Enclosed is the trip report written by the NRC staff following their visit to the Canonsburg UMTAP site on May 16 and 17, 1985. The report provides recommendations for DOE and NRC to consider in the performance of this remedial action. We hope that our observations and perceptions of the status of construction at Canonsburg will be helpful to you.

May 16-17, 1985 Canonsburg Trip Report

CANONSBURG UMTRA ON-SITE CONSTRUCTION REVIEW - MAY 16-17, 1985
prepared by
Steve Smykowski (WMEG) and William L. Dam (WMGT)

SITE AREA DESIGNATIONS

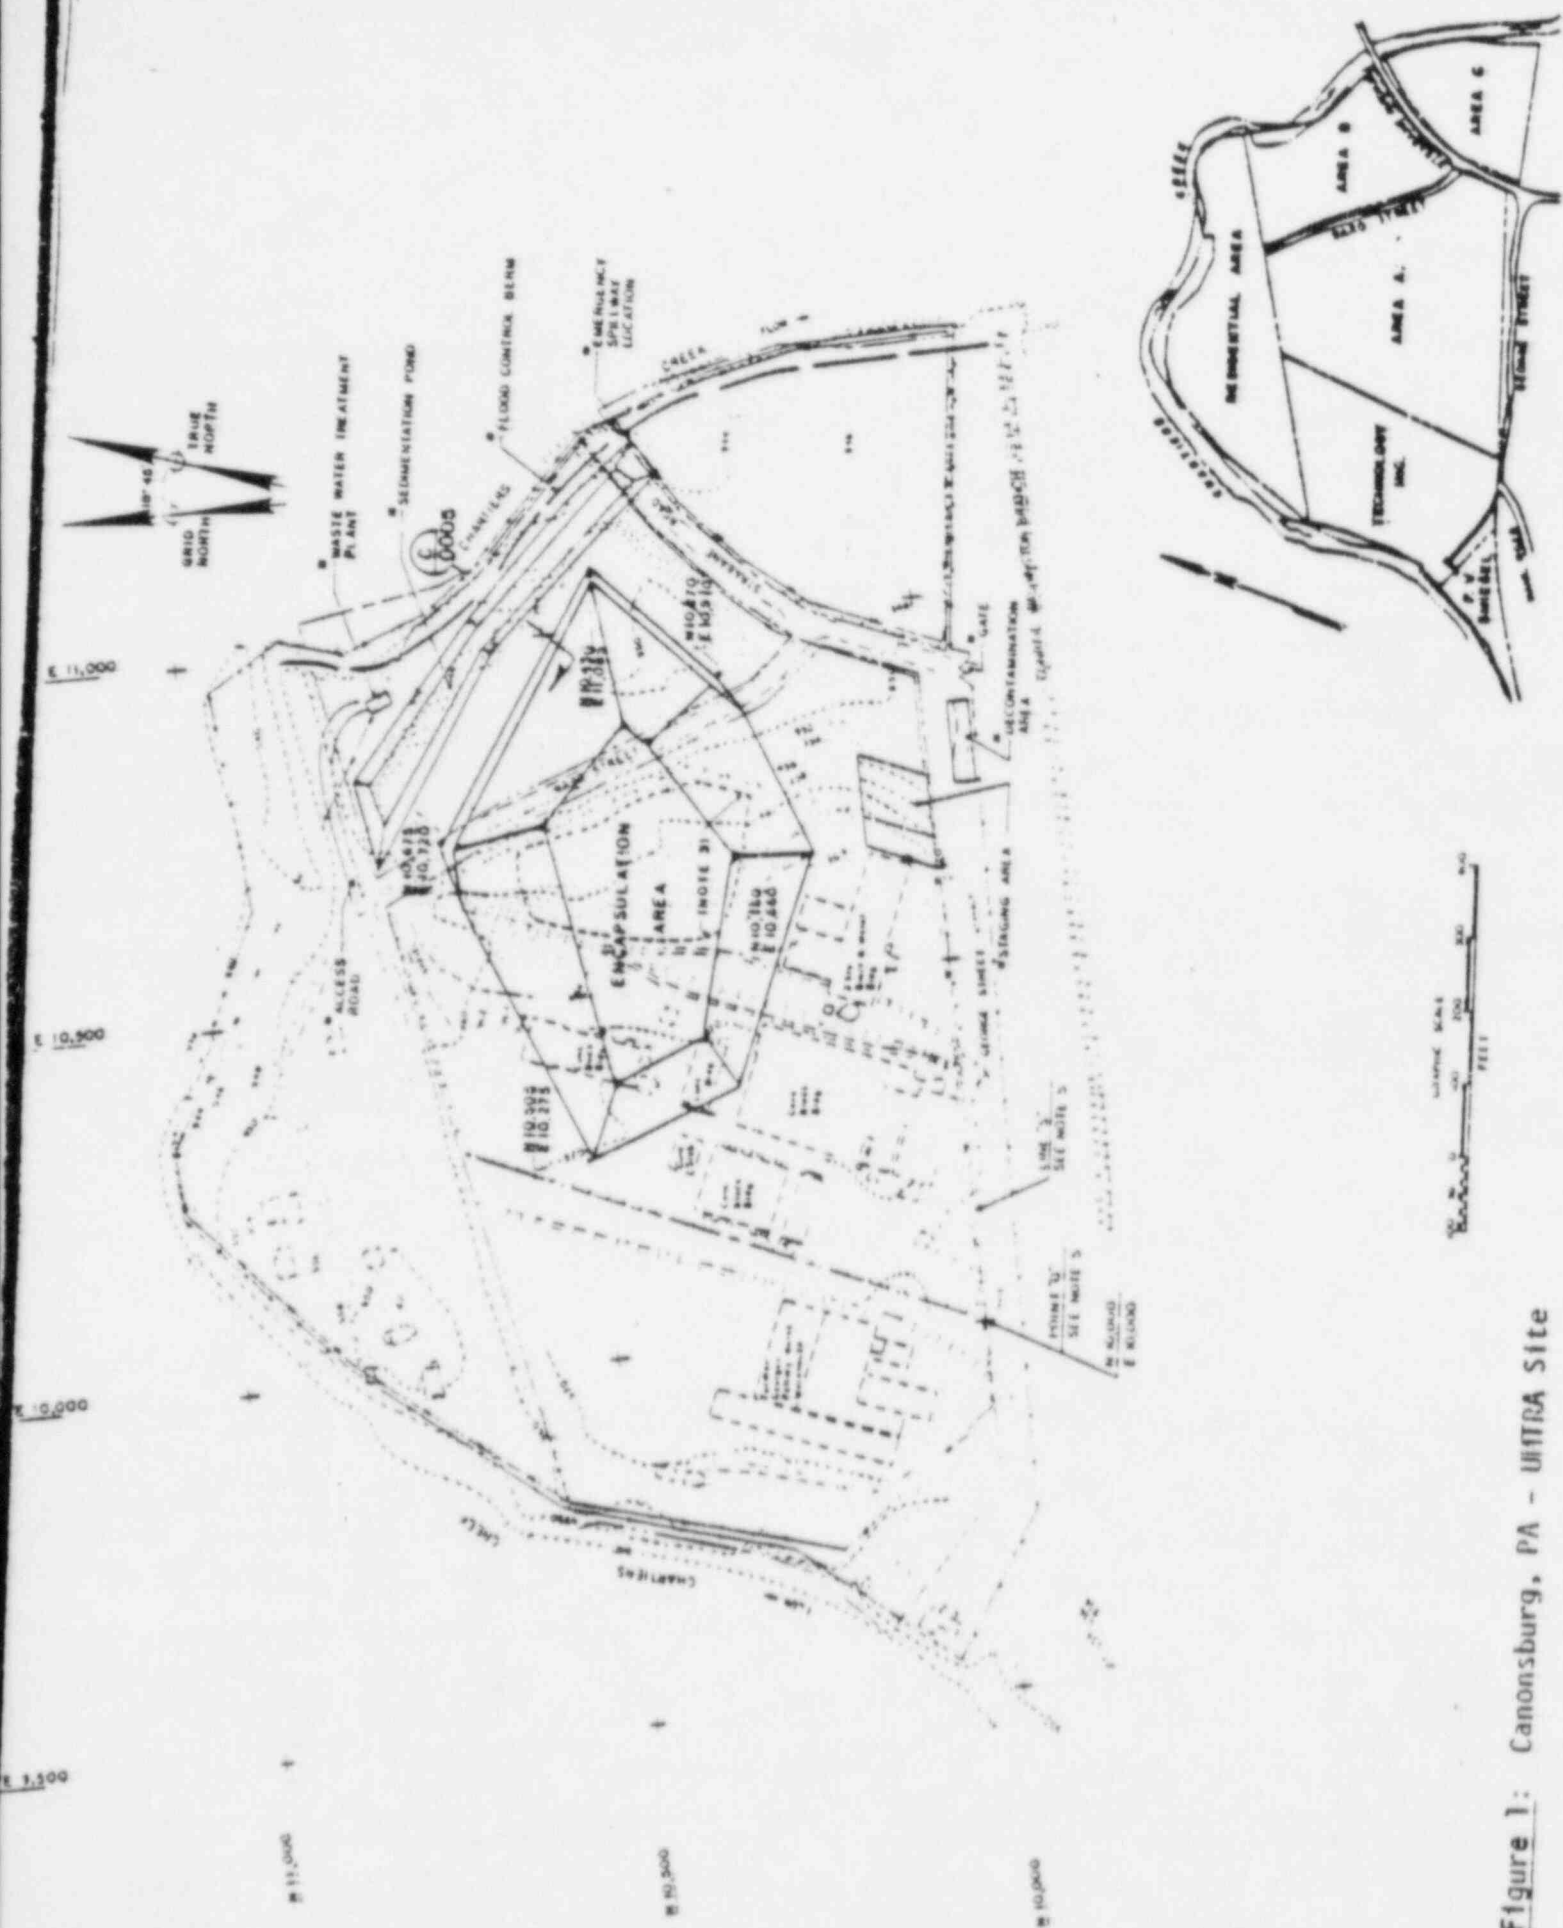
Area B is contiguous to Area A and is located east of its boundary (Figure 1). The major portion of the highly contaminated soil lens (estimated average radium concentration of 505 pCi/g) that the DOE has proposed to stabilize-in-place outside the encapsulation cell is located in this area. Although this lens also extends into the eastern portion of Area A where it will be covered by the encapsulation cell, a large portion of the lens in Area B will not be covered by the cell.

By letter dated April 3, 1985 from Themelis (DOE) to Nixon (NRC), the DOE and RAC indicated that the contaminated soil lens extends from the eastern edge of the encapsulation cell to the surface water collection pond. However, during the site visit, we learned that the lens is more extensive than what was originally communicated to the NRC. Larry Farnes (RAC) indicated that a portion of the lens can also be found between the collection pond and Chartiers Creek (Figure 1).

- c) Lens Between Pond and Creek - The RAC indicated that the contaminated lens material between the collection pond and Chartiers Creek will be removed and placed in the encapsulation cell. This area is located outside the buried riprap wall. Soil removal may be particularly difficult in this area because a cut bank of the creek is in the proximity of the contaminated soil lens. The stream may further erode the contaminated soil during excavation and result in mixing of soil and water. Precautions should be taken to avoid deposition of contaminated material in the creek because the material could become a long-term source of heavy metal and radioactive contamination. The resulting impact would depend on the concentration of the material and the amount deposited in the creek.

The proposed modification to the RAP for disposal of the contaminated soil in this Area now includes removing trees and vegetation from the floodplain and river bank and placing the stumps and roots inside the

The area west of Area A identified as Technology Inc. in Figure 1 contains buried contaminated material (average radium concentration not exceeding 100 pCi/g) covered with 2 feet of site cover material. The contaminated material consists of construction materials from buildings that were demolished on the site. Don Summers (RAC) indicated that no organic material was buried in this area. The site cover material was placed and compacted last fall. No signs of rutting or differential settlement were evident.
